Draft decision

Jemena electricity distribution determination

1 July 2026 – 30 June 2031

Attachment 2 – Capital expenditure

Figure 2.1 Jemena's historical and forecast capex (\$ million, \$2025–26)

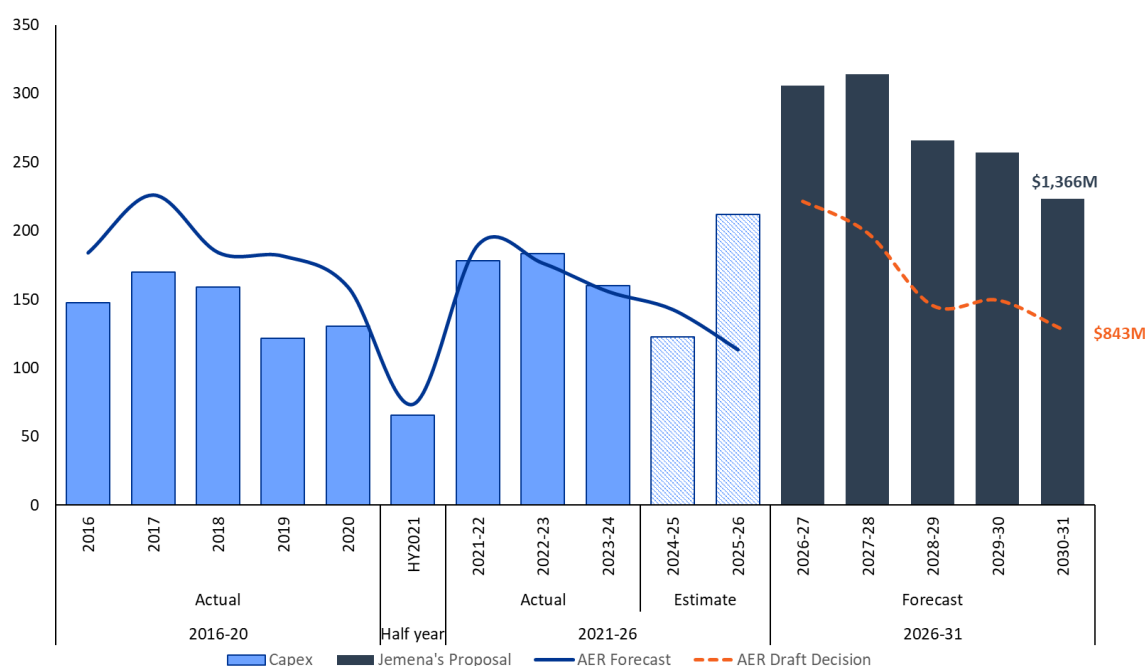
As can be seen in Figure 2.1, Jemena is proposing a material step up in the forecast period relative to the current period. We also observe a material overspend in the current period. The main driver of the overspend in the current period is due to increased data centre investment towards the end of the period.¹⁶

Figure 2.1 also shows that while our draft decision is a large reduction to Jemena's forecast, it is broadly on trend with Jemena's current period actual/estimate of \$836.4 million. As noted, our draft decision includes several placeholder values where we are seeking further information from Jemena in its revised proposal.
